CITY PLANNING COMMISSION

APPLICATION: 1. Negative Declaration
2. Development Plan Review of 134-unit apartment complex on 6.4± acres in the R-2B-R zone (13-A-3-C-4) (P84-113)

MEETING DATE April 26, 1984

RUSH RIVER APARTMENTS

EXHIBIT A

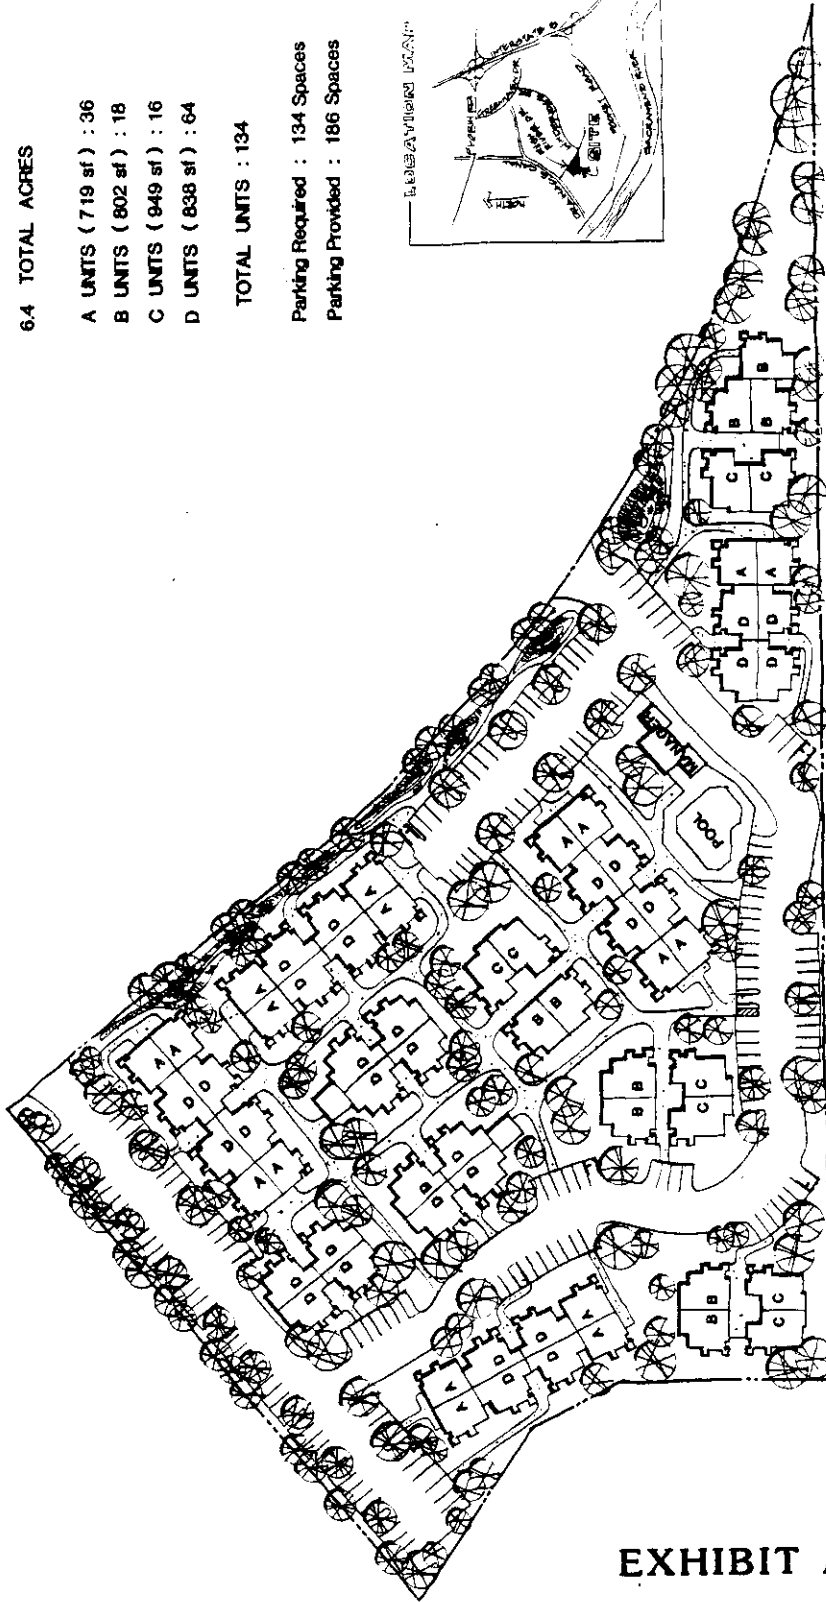
1. The site plan indicates a cluster of units that will be located along the westerly boundary of the site adjacent to future single family units. These units are approximately 20 feet from the property line. In order to reduce overview of the second story apartment units into the rear yards of abutting residences, staff suggests that the setback be increased to a minimum of 25 feet.

In addition, staff suggests intense landscaping be provided along the westerly property line.

2. Parking is to be provided along the northwesterly property line. Intense landscaping is also appropriate as a buffer between the apartment parking and the rear yards of zero lot line residences.
3. The site plan does not provide dimensioning of setbacks, parking spaces, distances between buildings, etc. There are no apparent problems; however, the project will be reviewed on the more detailed plan to be submitted at the time of building permit application. Compliance with the Zoning Ordinance, Building Codes, and the attached Multiple Family Design Criteria (see Exhibit C) will be required at that time.

1. Increased setback of structures along the southwest property line to a minimum of 25 feet;
2. Intense landscaping along the westerly and northwest property lines for purposes of visual and noise buffering shall be provided;
3. Compliance with the Multiple Family Design Criteria;
4. A detailed landscaping and irrigation plan shall be submitted for staff review and approval prior to issuance of any building permit.
